| Project Title: | 2025 Energy Code Pre-Rulemaking |
| Document Title: | Taylor Engineers Comments - Express Terms Comments |

To: CEC
 From: Jeff Stein
 Subject: Docket Number: 22-BSTD-01 Express Terms
 Date: November 17, 2023

To: CEC
From: Jeff Stein
Subject: Docket Number: 22-BSTD-01 (Heat Pump Baselines)
Date: August 9, 2023

Figure 1

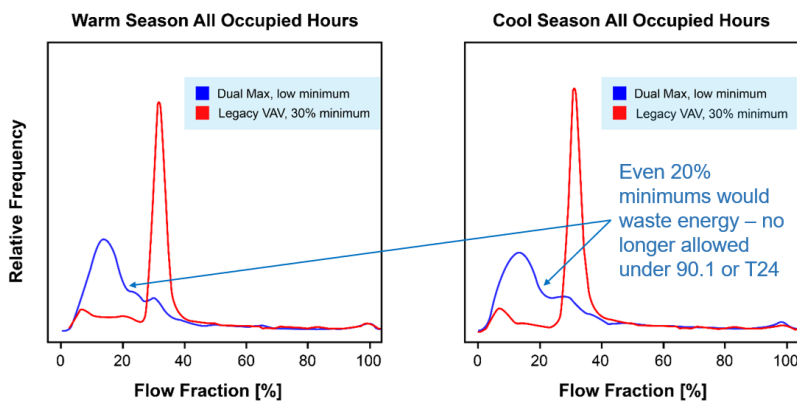
1. [ASHRAE RP-1515](#) was a long term study of many office buildings with thousands of zones. When the VAVR zone minimums were reduced from 30% to 10-15% almost all zones spent almost all their time at the new zone minimums, meaning that real zone loads are rarely more than 10-15% of their design values. See Figure 1 below.

Figure 2

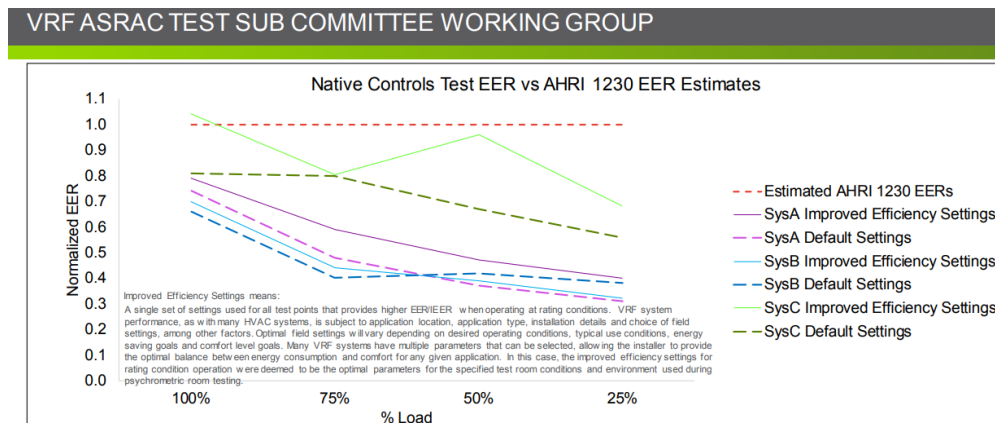
- v. Other features of VAVR that are often modeled incorrectly are supply air temperature reset and duct static pressure reset.
 - b. Third party testing of VRF equipment by [PG&E](#), [Guidehouse](#), and [DOE](#) has shown that the efficiency claims by the AHRI ratings are overstated, particularly in terms of heat recovery efficiency. For, example, Figure 2 shows that the real measured EERs are about half of what the ratings predict, i.e. VRF uses twice the energy expected by CBECC.
